## RESPONSE TO COMMENTS ON CRYSTAL RIVER UNIT 3 UPRATE PROJECT SITE CERTIFICATION APPLICATION

August 2007

**RESPONSE TO COMMENTS  
ON  
CRYSTAL RIVER UNIT #3 UPRATE PROJECT  
SITE CERTIFICATION APPLICATION**

**CRYSTAL RIVER UNITS 1, 2, AND 3  
WATER BALANCES**

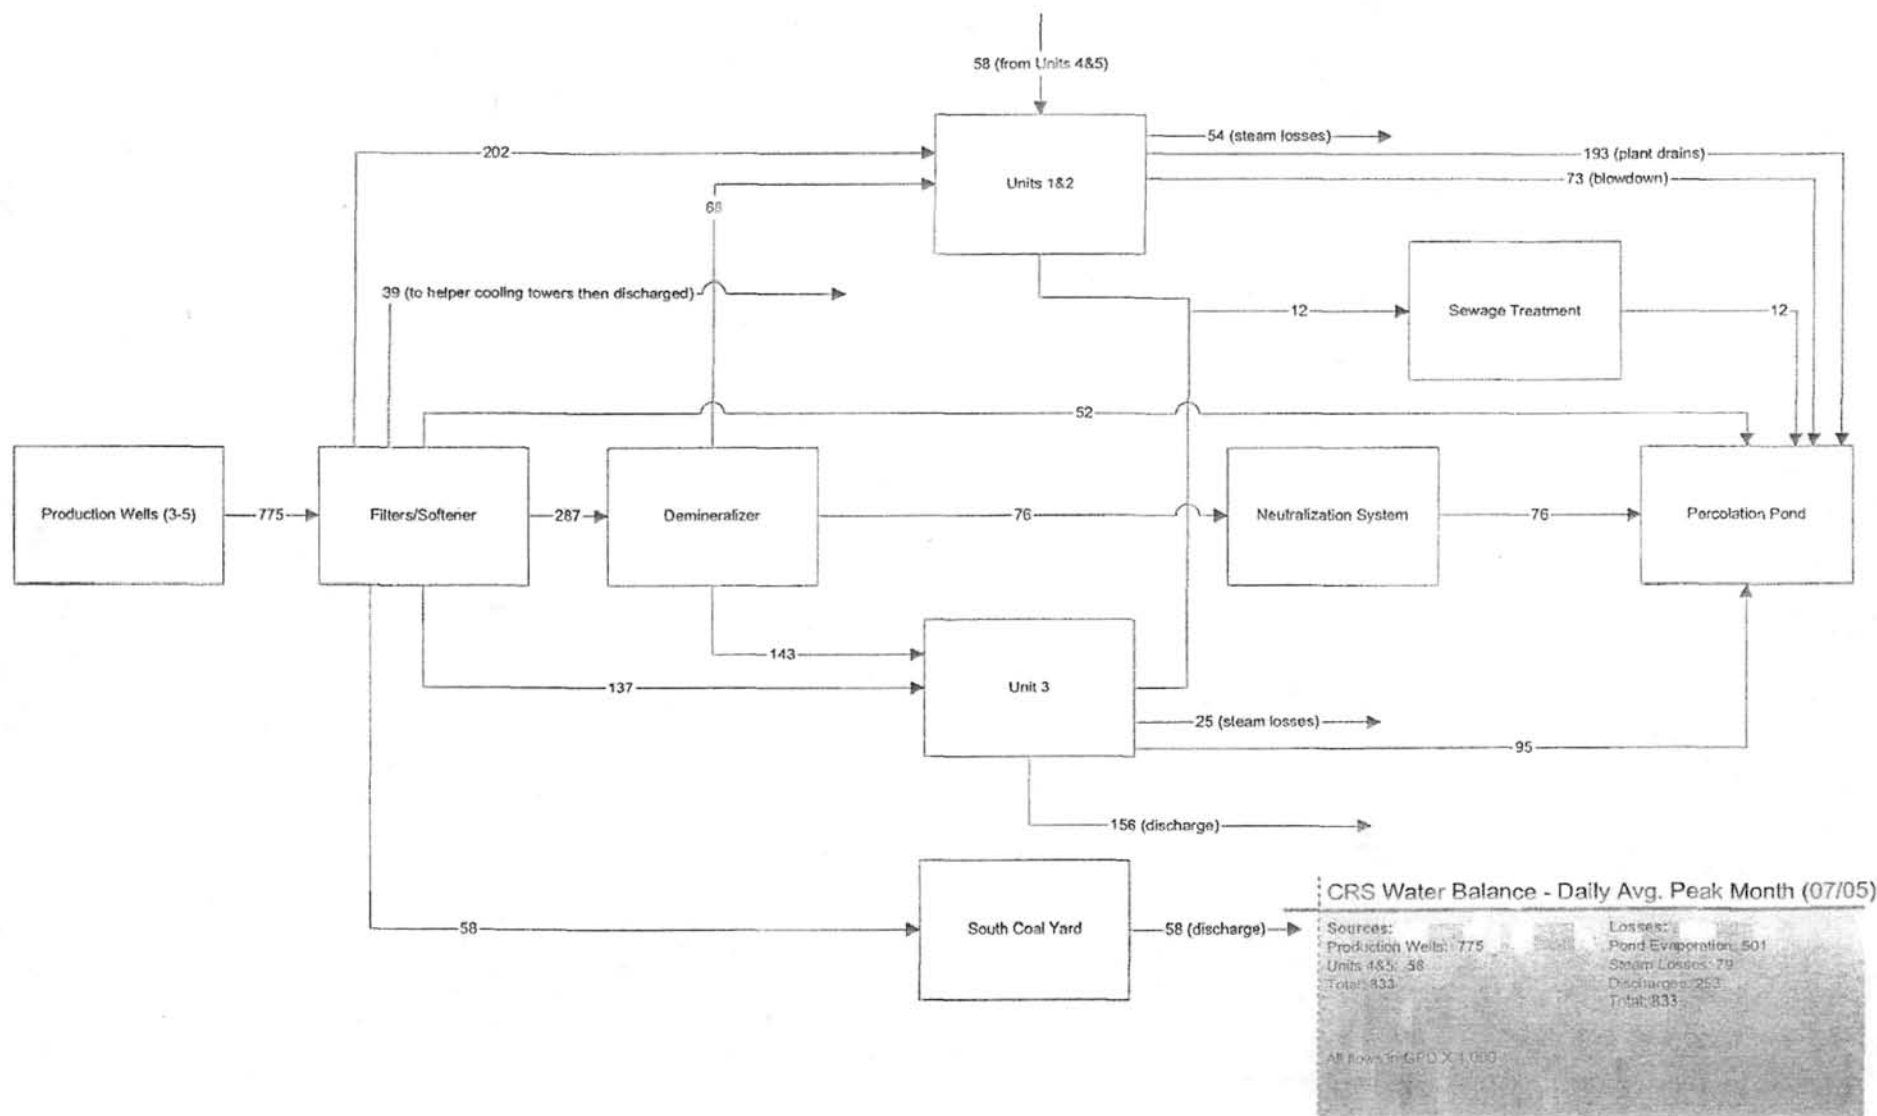
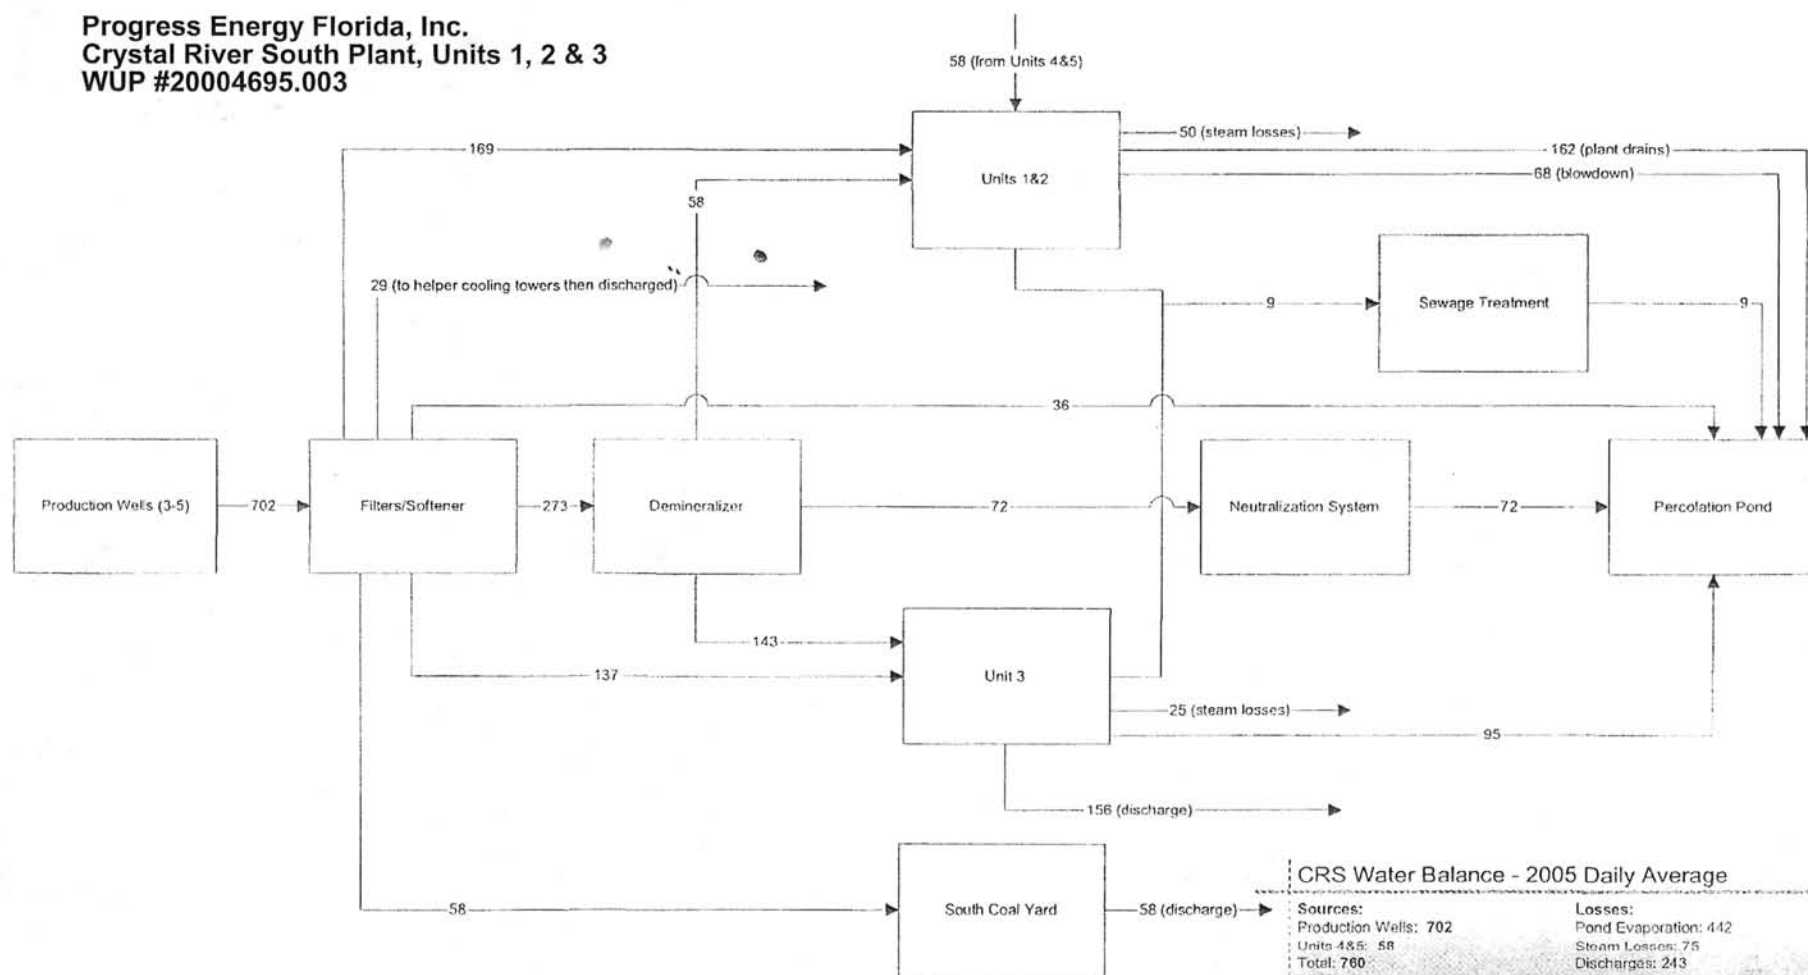
4. Please provide adequate information showing the distribution and use (water balance) of water from each well (PW-1A, PW-16, SPWS, SPW-4, and SPW-5).
